**CITY OF SAMMAMISH
SAMMAMISH ADDENDUM TO THE
2021 KING COUNTY SURFACE WATER DESIGN MANUAL
Revised Date: July 2, 2024
Effective Date: October 1, 2024**

PREFACE – How to Use this Document

Section 4.1.2 EASEMENT AND SETBACK REQUIREMENTS (page 4-3 of the KCSWDM) – Add the following figure as a supplement:

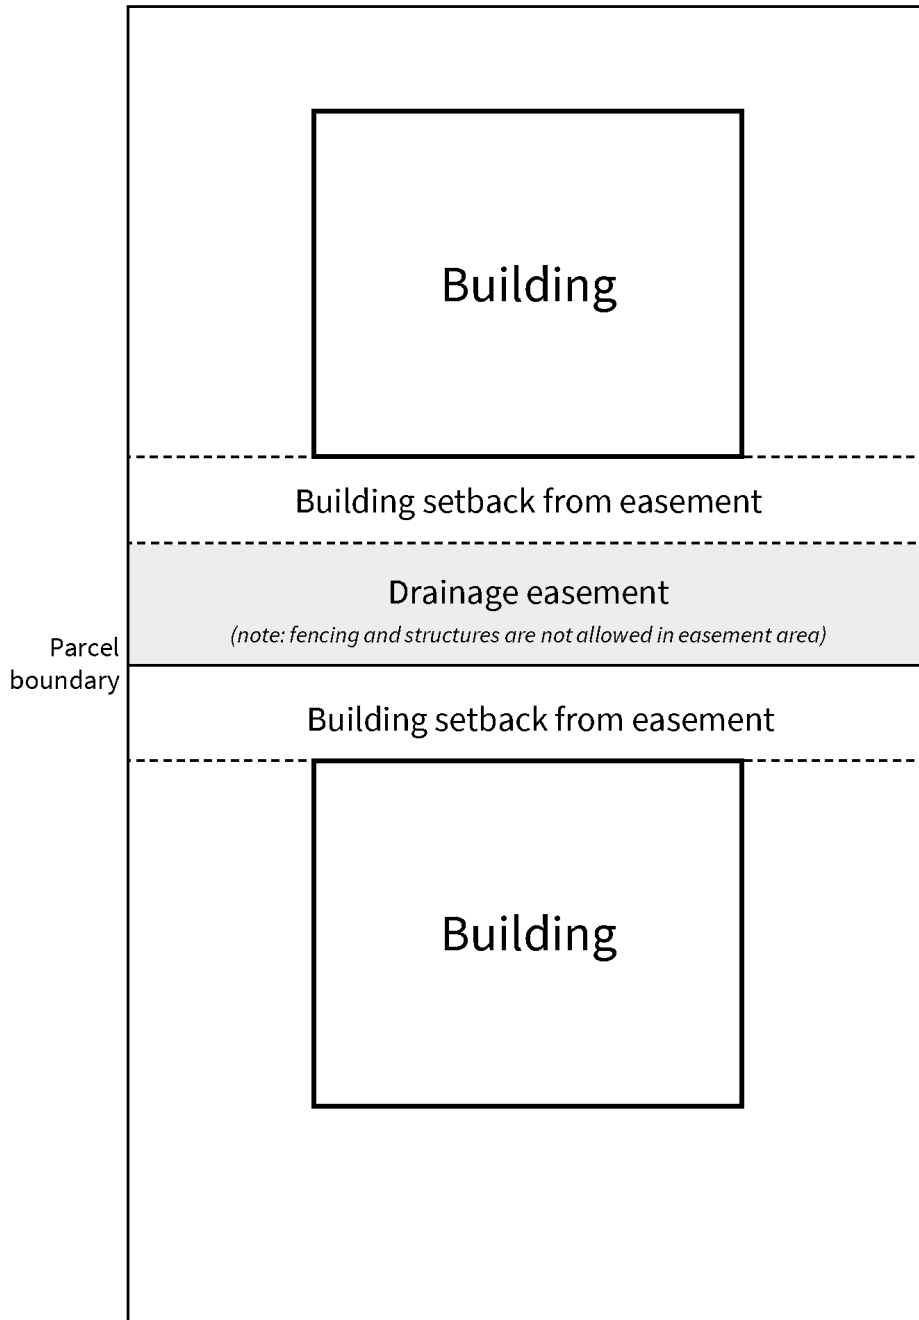
See Section 4.1.2 of the King County Surface Water Design Manual for easement and setback details.

- **Section C.2.4.1 MINIMUM DESIGN REQUIREMENT FOR BASIC DISPERSION** requirement .5 (page C-61) is replaced as follows:

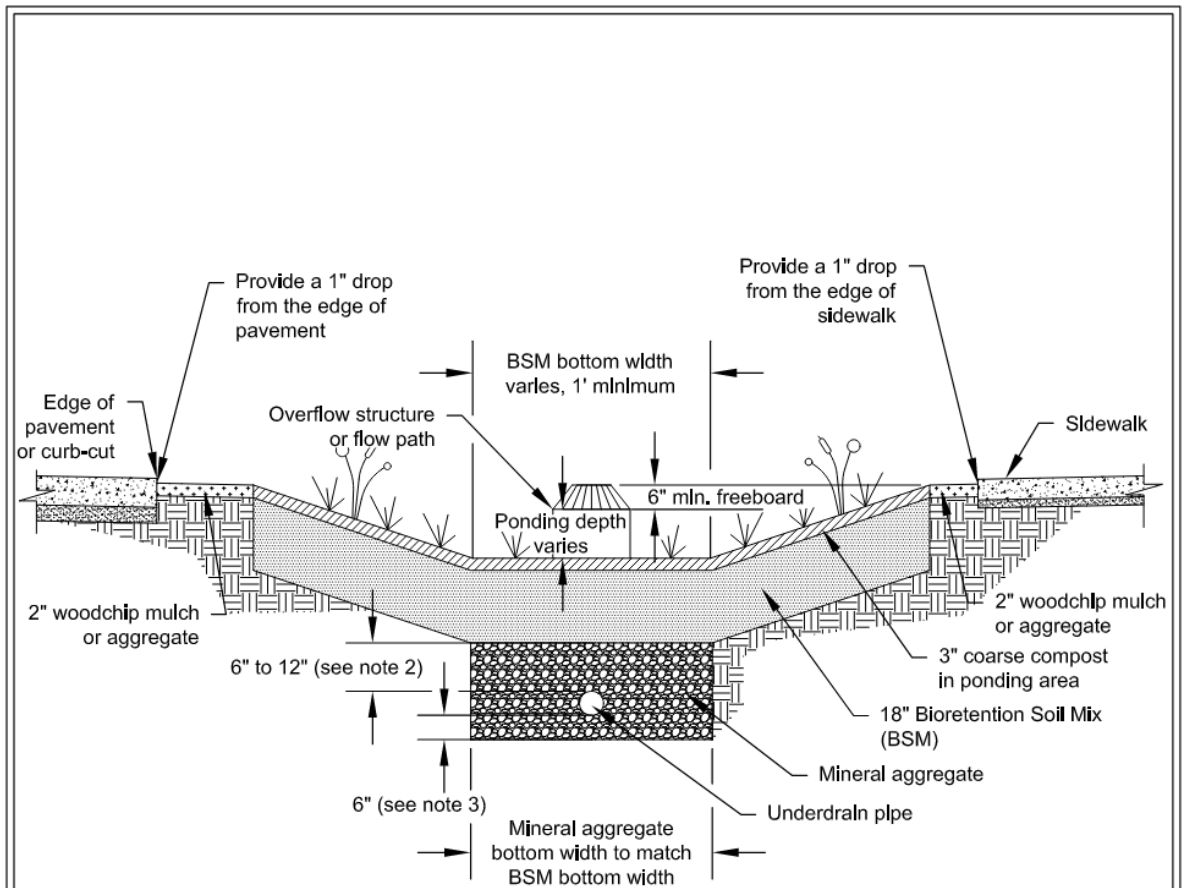
5. Dispersion devices are not allowed within 50 feet of the top of an erosion hazard area or landslide hazard area. Dispersion devices may be permitted within 50 feet of the toe of an erosion hazard area or a landslide hazard area when a report provided by a geotechnical engineer or engineering geologist addressing the effectiveness and safety of the design is submitted to DCD for review. In no case shall a dispersion device be permitted within 15 feet of a landslide hazard area.

Attachment A: Stormwater Pond Design Intent

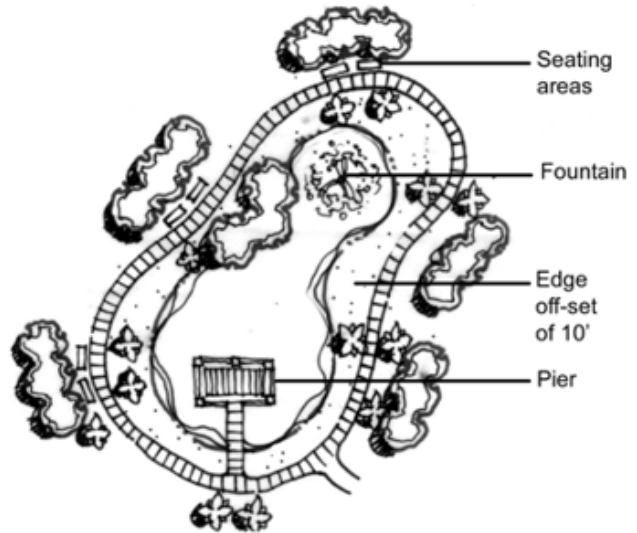
POOR POND DESIGN

GOOD POND DESIGN

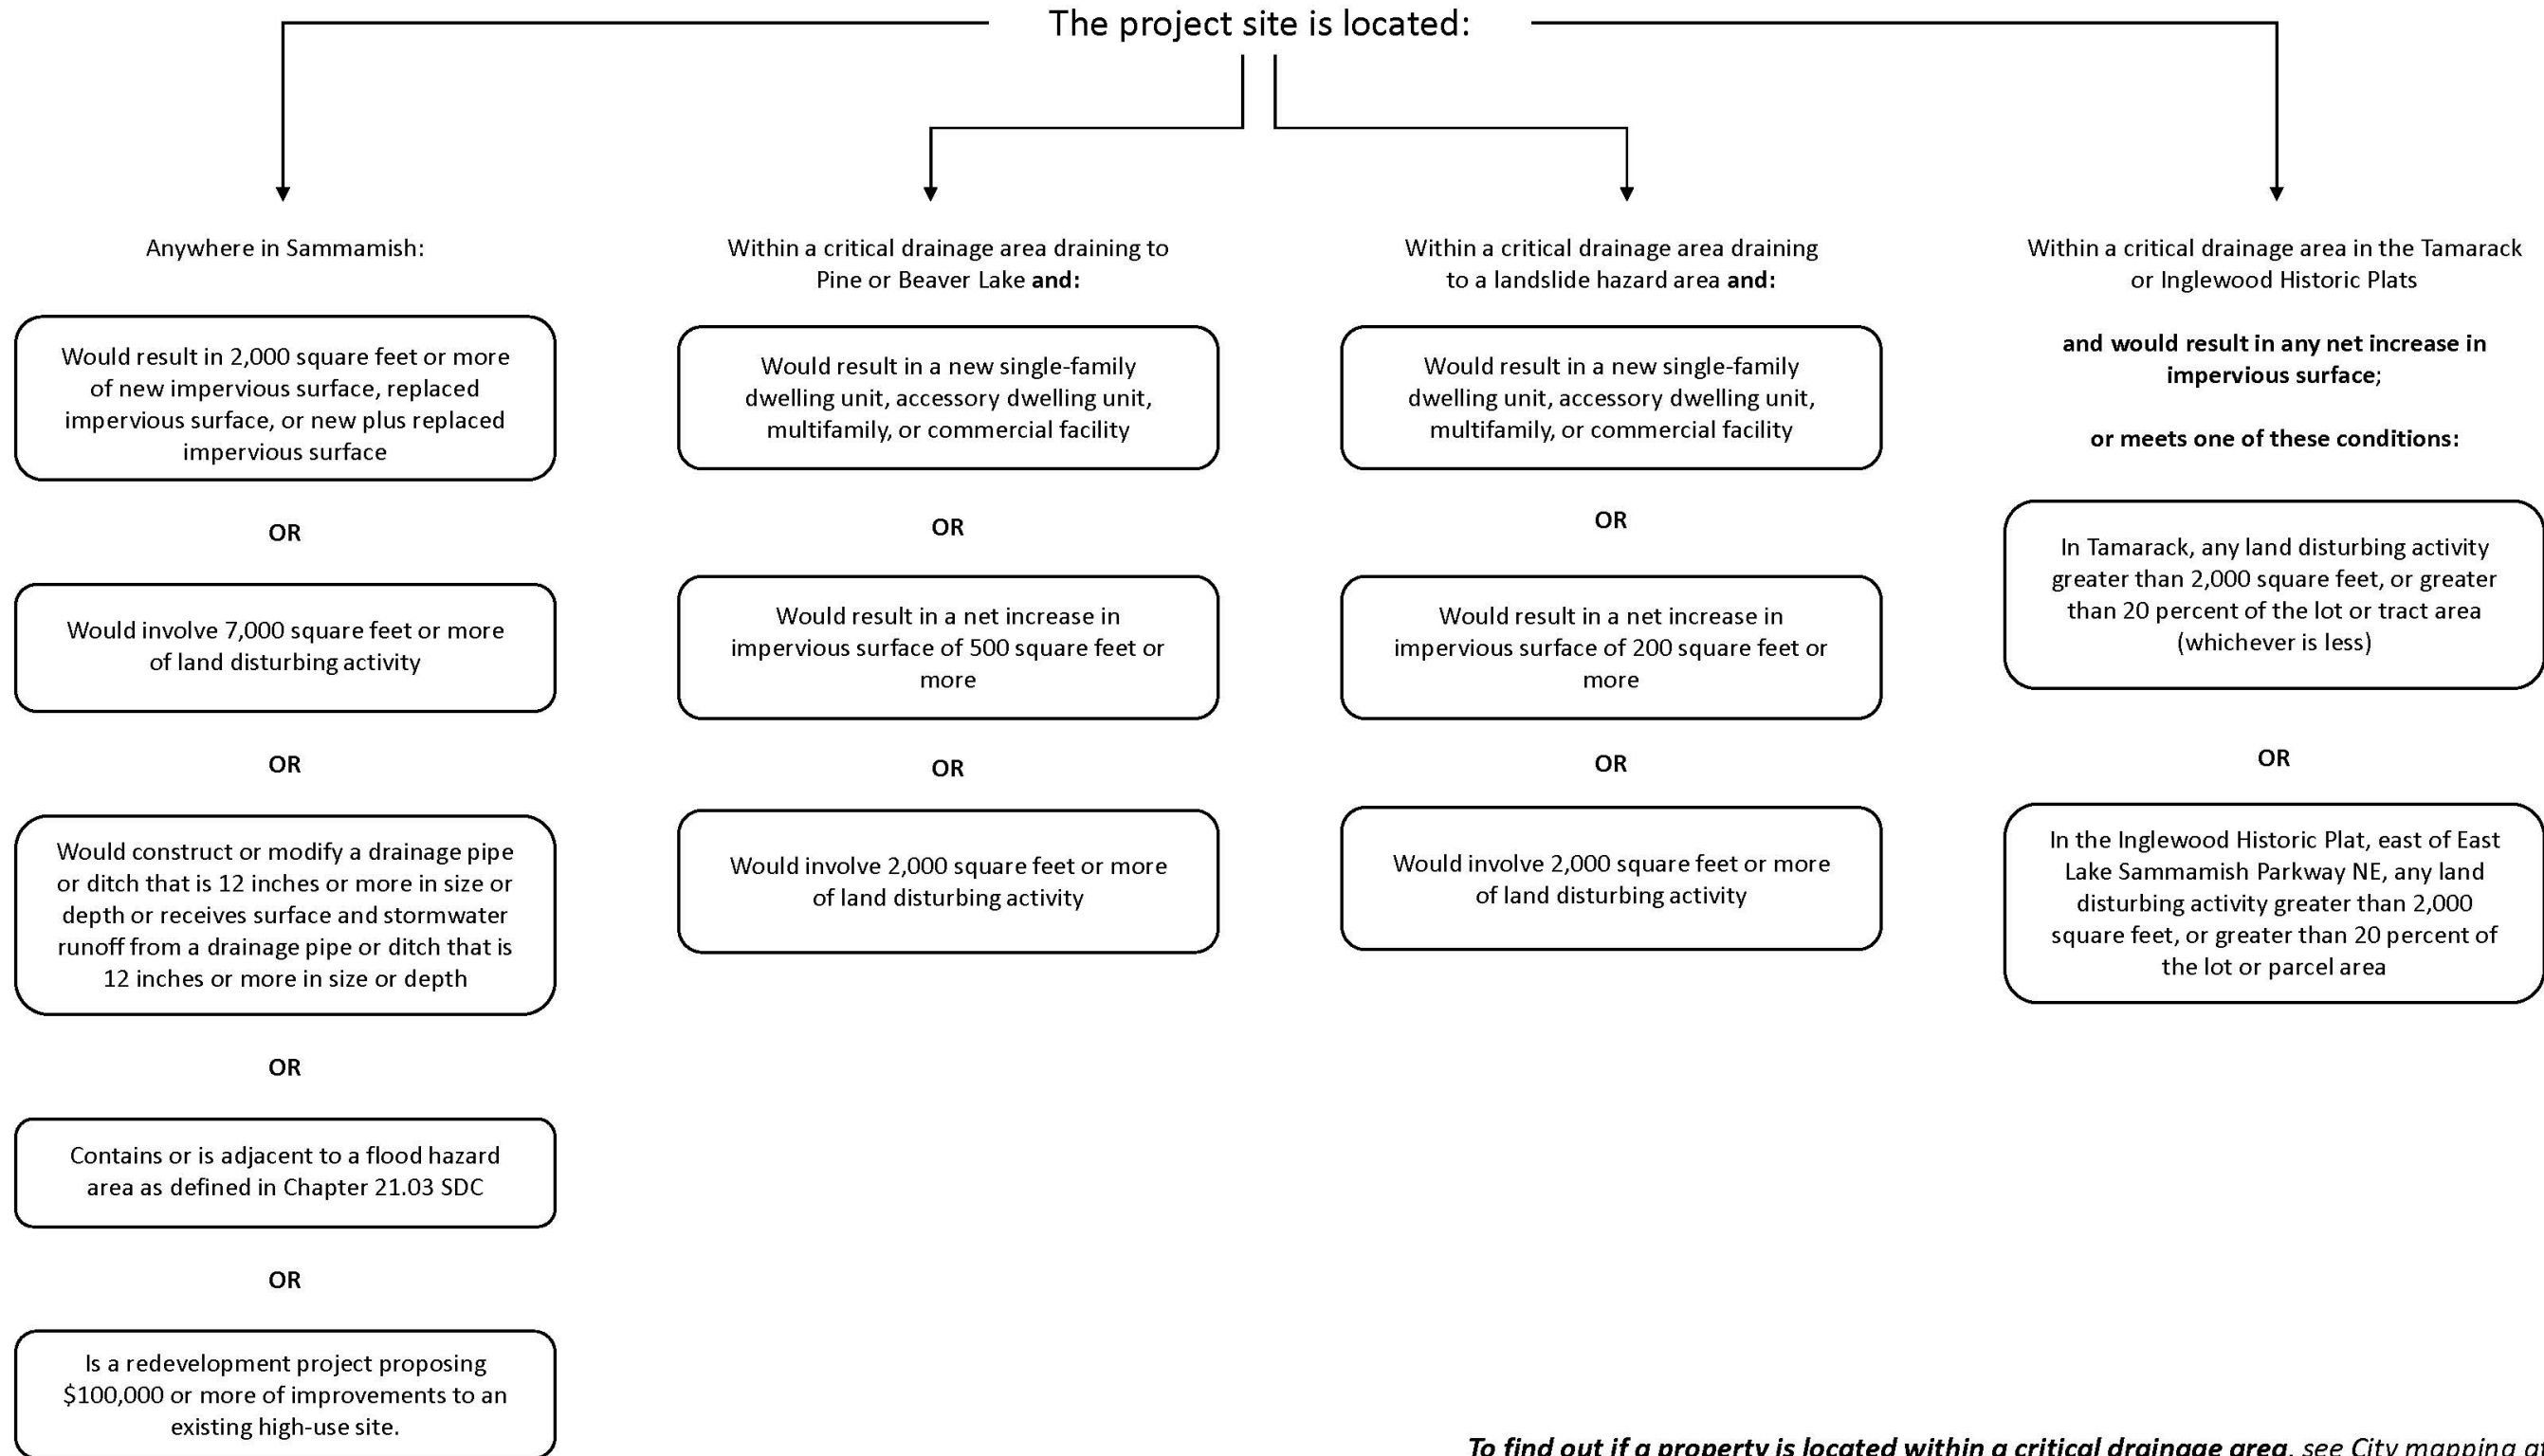
- **Section 5.1.1.1 DESIGN CRITERIA, Figure 5.1.1.D Stormwater Facility Signs (page 5-16 of the 2021 KCSWDM)** — Replace Figure 5.1.1.D with the figure in Attachment B of this addendum.
- **Section 5.1.3.1 DESIGN CRITERIA, Setbacks (page 5-23 of the 2021 KCSWDM)** – Add the following sentence at the end of the paragraph that begins “Setbacks to tract/easement lines for vaults...”:
